# Service Tips from the Pros

## Retrofit the SCS Keyless Entry System to the Tri-Mark Keyless Entry System.

#176367-01-000 Tri-Mark Keyless Entry & Cargo Lock System

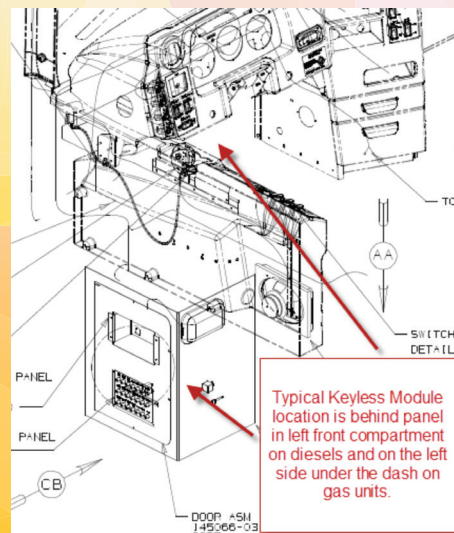
Motor homes previously equipped with SCS Keyless Entry & Cargo Lock System (#151458-01-000) or Keyless Entry Only System (#151458-03-000), contain keyless systems that are no longer serviceable. If the module, the keypad or the key fob fails, a new Tri-Mark Keyless Entry System will need to be installed to regain full functionality of the system.

The following parts are required to properly retrofit the Tri-mark Keyless Entry System as a replacement for the SCS systems:

#151458-01-000 Original SCS System; required parts are listed below.

#176356-01-000 Wire Assembly Keyless Entry & Cargo Lock

#063912-02-000 Relay (2 required)
